Addendum Number One

New Mexico Highlands University

Invitation for Bid #873-Engineering Building Drainage Improvements

Las Vegas, New Mexico

STANDARD CURB & GUTTER

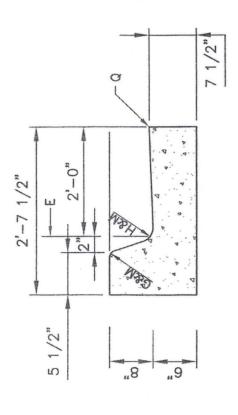
1) Keyed note #1 on Sheet G-1 for the 8-inch curb and gutter suggest that the detail for the curb and gutter is indicated on Sheet G-1, but is not present. Attached is the curb & gutter detail to be used for this project.
